## **ADDENDUM No. 1**

### **RFP No. 2026-02**

#### **FOURTH AVENUE RECONSTRUCTION**

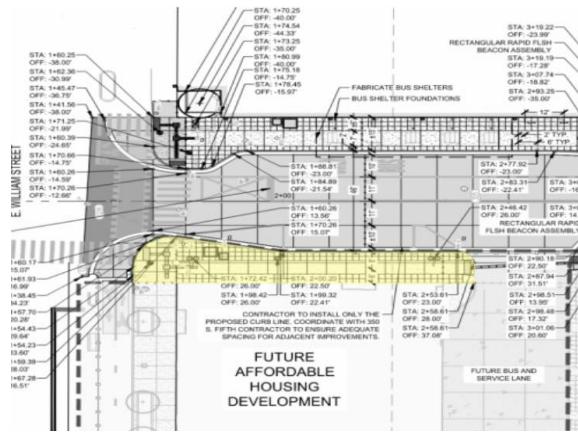
Question 3: Referencing the sketch provided, please confirm that all work beyond the back of curb, extending to the face of the future affordable housing development, is by others. This includes, but is not limited to, removals of existing items, sidewalk pavement, traffic signals and associated conduits, and landscaping within this area.

Answer 3: All removal and demolition work within the identified area and illustrated on the plans is to be included in this contract. Restoration work within this area, including sidewalk pavement, traffic signals and associated conduits, and landscaping, will be performed by others as part of the 350 S. Fifth Avenue development. Also note, the highlighted area should be extended from (approximately) Station 1+50 through Station 2+90 such that it includes the Future Bus and Service Lane.
